FIRE SAFETY INSPECTION REPORT

MTM GARMENTS LTD.

ACCORD ID: 12323

November 1, 2015

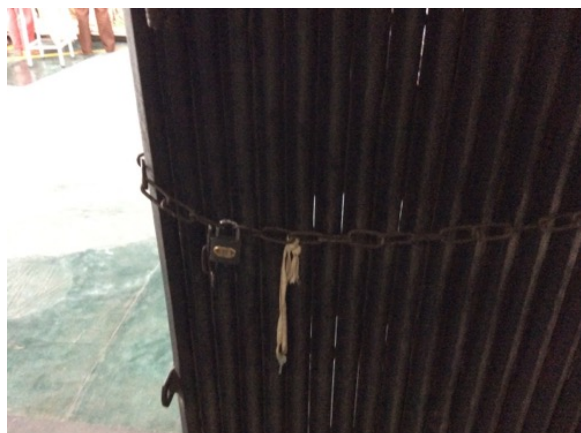
F-2	Fire Rated Construction	The boiler area on the first floor is not separated by fire-rated construction due to openings and non-rated doors.	Separate the boiler room by a minimum 1-hr fire-rated construction for non-high rise. Seal and/or protect all openings to maintain the required fire separations. Provide proper ventilation and consult a qualified engineer.	Within 3 months
-----	-------------------------	---	--	-----------------

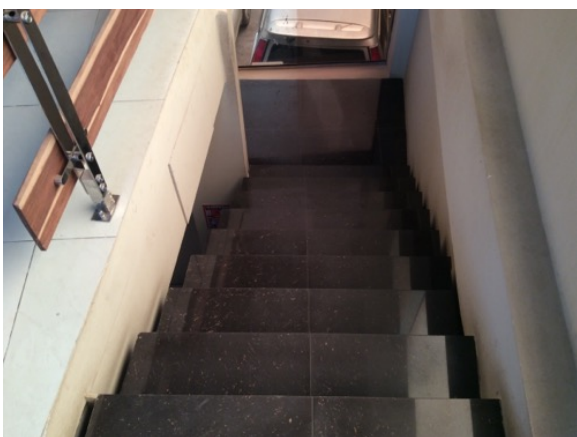
F-7	Egress	Handrails are not provided on both sides of the office exit stair.	Provide handrails on both sides of the exit stair. New handrails shall have a minimum height of 865 mm (34 in.) and a maximum height of 965 mm (38 in.) as measured from the leading edge of the tread. Intermediate handrails shall be provided when the stair width exceeds 2.2 m (87 in.) .	Within 3 months
-----	--------	--	--	-----------------
